From: Hon, Andrew
Sent: Wednesday, October 19, 2016 8:32 AM
To: Murray, William R. (Bill) (Bill.Murray@duke-energy.com) (Bill.Murray@duke-energy.com)
Subject: Audit Plan for Brunswick MELLLA+ License Amendment Request Review

REGULATORY AUDIT PLAN FOR BRUNSWICK STEAM ELECTRIC PLANT
UNIT NOS. 1 AND 2
TO SUPPORT REVIEW OF THE LICENSE AMENDMENT REQUEST
REGARDING CORE FLOW OPERATING RANGE
EXPANSION MAXIMUM EXTENDED LOAD LINE LIMIT ANALYSIS PLUS
DOCKET NOS. 50-325 AND 50-324

Figure 1 Schematic of first stage of mechanistic separator (Figure 10-13 [1])

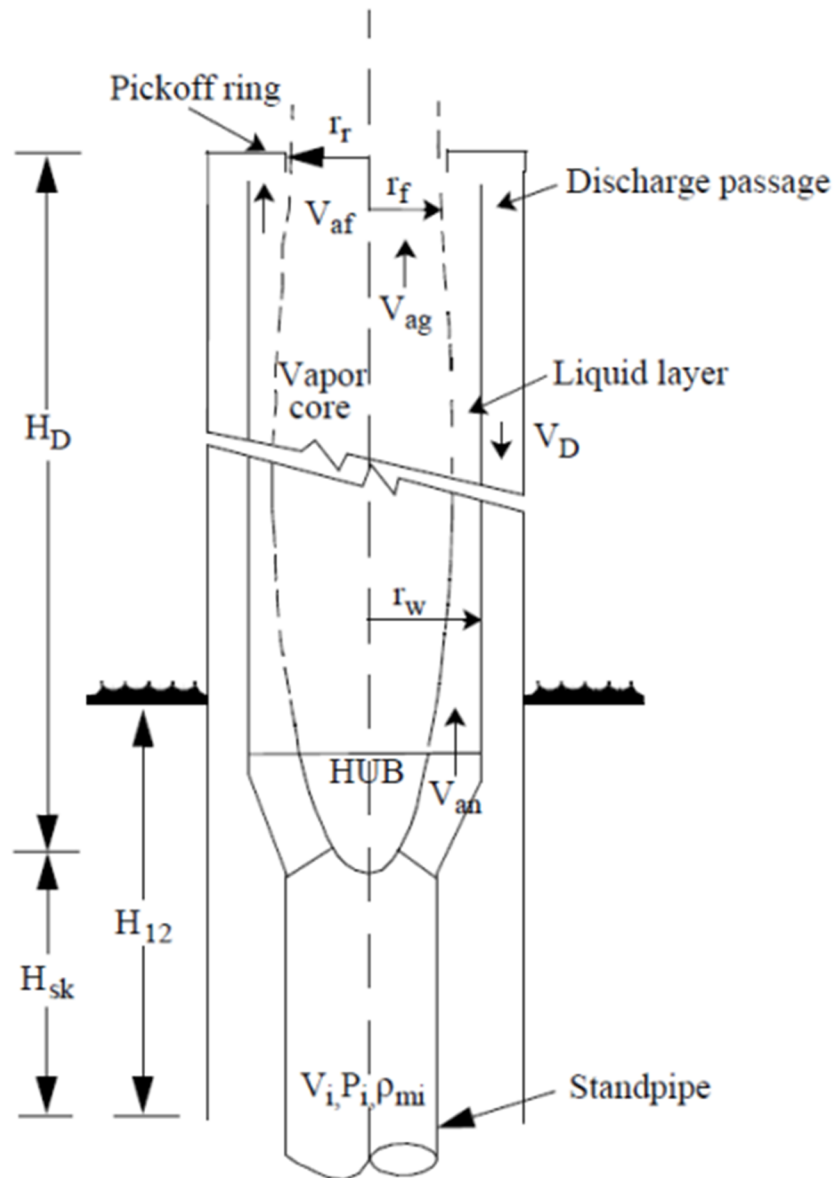
- a. Number of stages in the separators.
- b. Geometric data for each stage (wall radius, “pickoff” (liquid return) ring radius (see Figure 1), flow area, discharge diameter, barrel length, vane position, discharge loss, and effective L/D, or information from which these could be calculated).
- c. Hub inlet radius.
- d. Swirl vane angle relative to the horizontal (degrees).
- e. Free volumes for each separator (or in total) inside the standpipe, the conical (swirl vane) section, the inner cylinder of each stage, and the liquid return section for each stage.
- f. Arrangement (e.g., triangular or square lattice) and separator pitch.
